AIA[®] Document G714[™] – 2007

Construction Change Directive

PROJECT: <i>(Name and address)</i> 08-005 Harrison County Governmental Complex & Library, Katrina Supplemental CDBG Project No. R-109-024-02-KCR Harrison County, Mississippi	DIRECTIVE NUMBER: 003 DATE: August 10, 2010	OWNER: <input checked="" type="checkbox"/> ARCHITECT: <input checked="" type="checkbox"/> CONSULTANT: <input type="checkbox"/> CONTRACTOR: <input checked="" type="checkbox"/> FIELD: <input type="checkbox"/> OTHER: <input type="checkbox"/>
TO CONTRACTOR: <i>(Name and address)</i> Trademark Construction, Inc. P.O. Box 8710 Mobile, AL 36689 1764 Industrial Prk Drive Mobile, AL 36693-5650	CONTRACT FOR: General Construction CONTRACT DATED: August 24, 2009 ARCHITECT'S PROJECT NUMBER: 08-005

The Contractor is authorized to expend Base Bid Contingency Allowance funds as follows:

1 ELECTRICAL LIGHTING FIRST FLOOR PLAN
PLAN NORTH
SCALE: 1/8" = 1'-0"

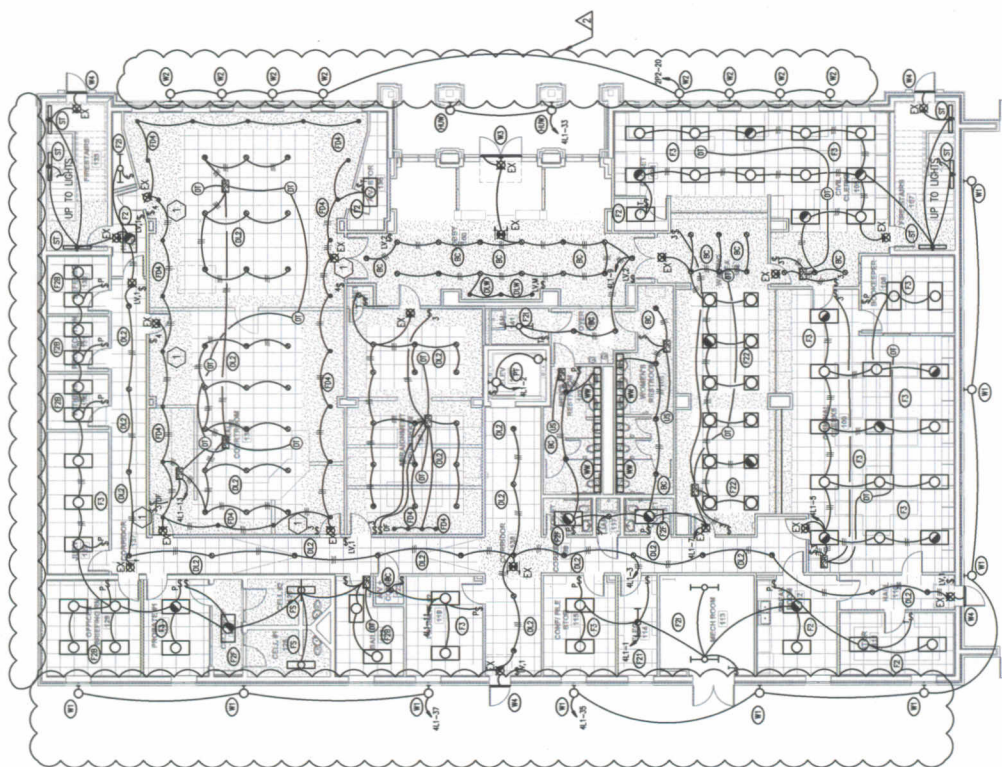
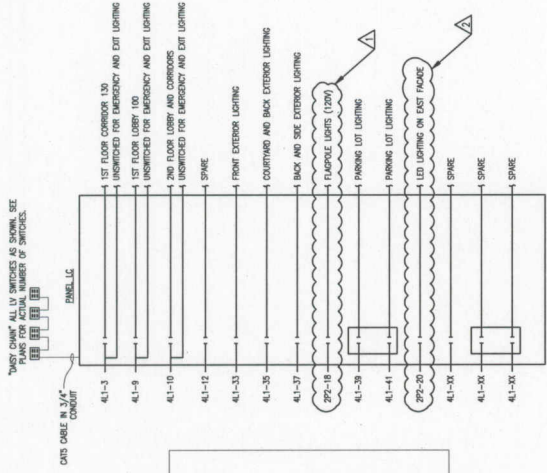
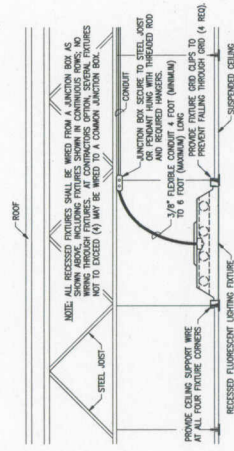
We propose to furnish the materials, labor and equipment to complete this electrical work as described: Changes to Exterior Lighting as per Proposal Request #11, Delete 7 each W1 Gardco fixtures and add 8 each W2 Beta Calco fixtures. Conduits, Boxes, wiring and Labor to install included in this pricing.

The attached sheet A200R shows exterior lighting mounting heights as well as revisions to the location and quantity of exterior lights along the East and North facade of the building.

Revised architectural sheet A200R, dated 04.30.10 and revised electrical sheets E002, E111, E201, and E402, dated 05.05.10 (5)

PLAN NORTH
 1 ELECTRICAL POWER SECOND FLOOR PLAN
 SCALE 1/8"=1'-0"

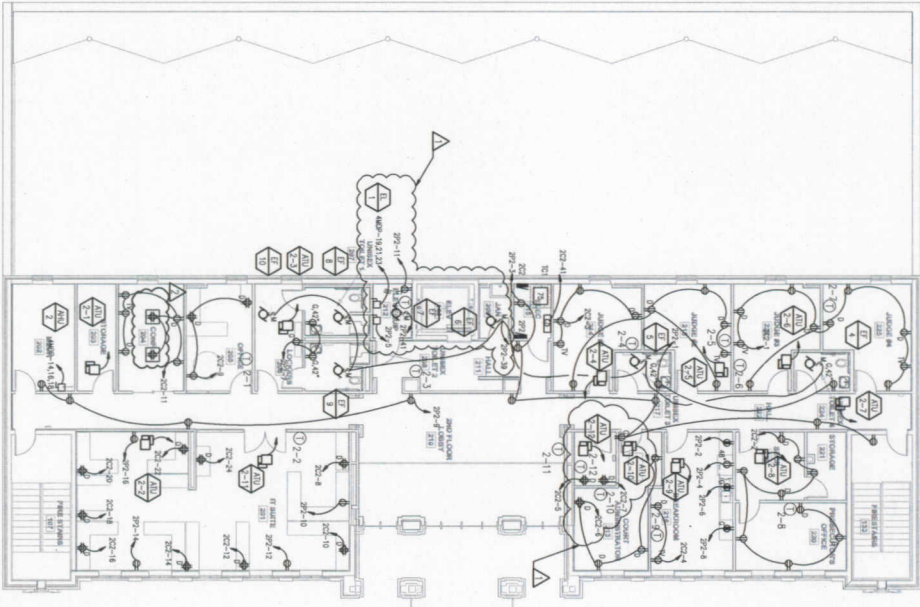
Provide two additional quad electrical receptacles in the floor of Judicial Complex Conference Room 204 as per the attached revised second floor power plan E122R.

Provide two additional quad electrical receptacles in the floor of Conference Room 204 as per the attached revised second floor power plan.

Revised sheet E122R, dated 04.01.10

3 !!! REVISED ELEVATION- LOBBY 100
WCPR #3 3/8" = 1'-0"

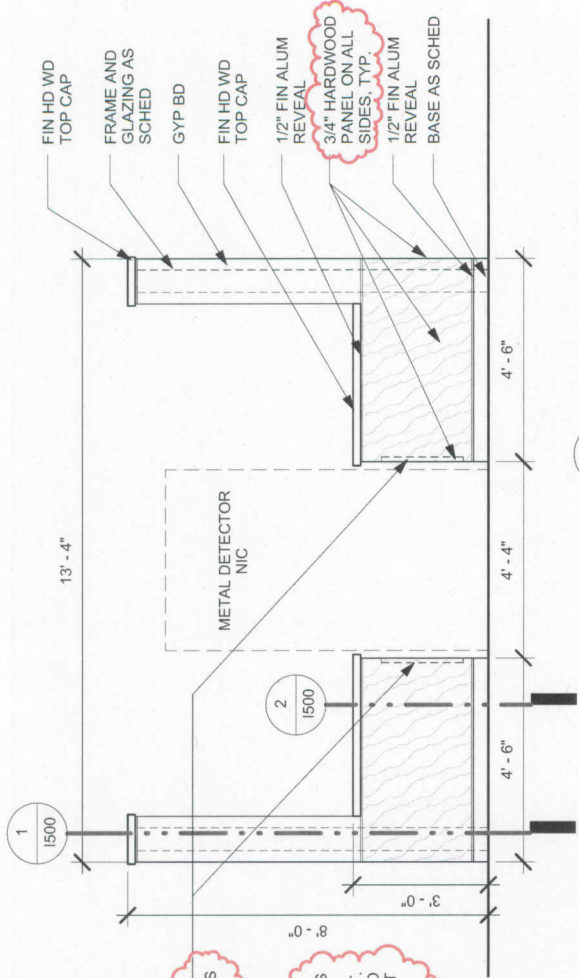
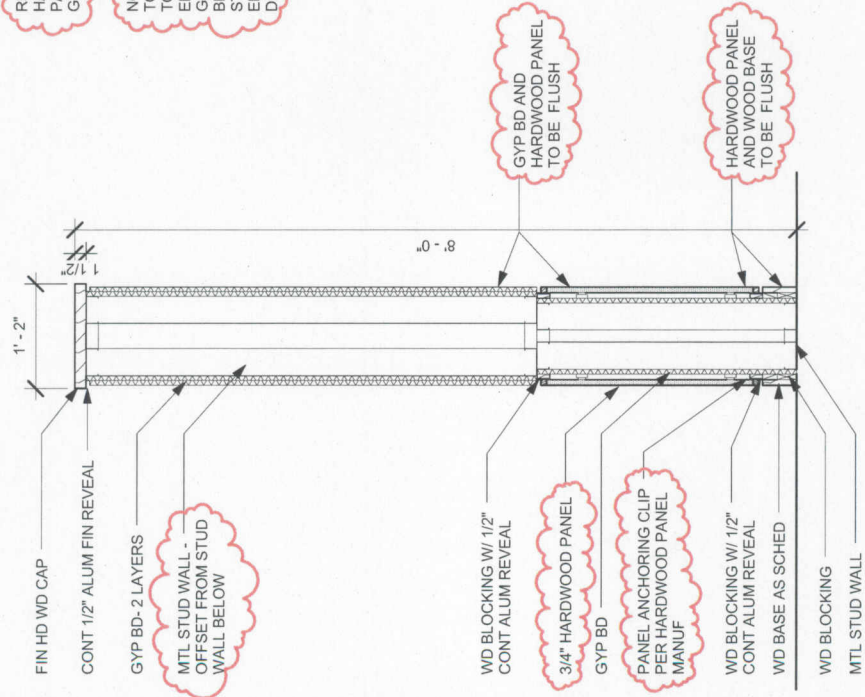
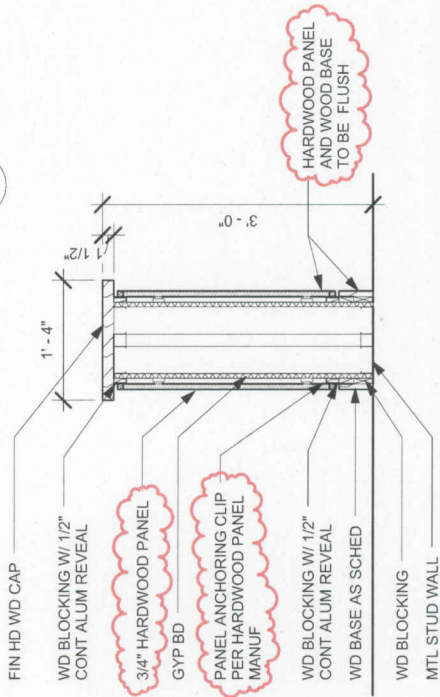
1. Deduct for installation of Natural Stone Veneer Panels as indicated by the text note "Stone Ply" and "Stone Veneer (ST1)" on drawings 1/ I400, 1/ I500, and 2/ I500. See attached sheet WCPR #3 for scope revised details.
2. Cost change associated with the installation of finished hardwood panels and supporting hardware at the Justice Court Building, Lobby Room 100 as indicated on attached sheet WCPR #3.

REMOVABLE HARDWOOD ACCESS PANEL W/ FIN ALUM GROMMET

NOTE: GROMMET IS TO PROVIDE ACCESS TO CONCEAL ELECTRICAL OUTLET. GROMMET NEEDS TO BE SIZED TO ACCEPT STANDARD ELECTRICAL PLUG DIAMETER.

GYP BD AND HARDWOOD PANEL TO BE FLUSH

HARDWOOD PANEL AND WOOD BASE TO BE FLUSH

HARDWOOD PANEL AND WOOD BASE TO BE FLUSH

1. WCPR #3 - Supplemental Drawing - Justice Court Entry Millwork
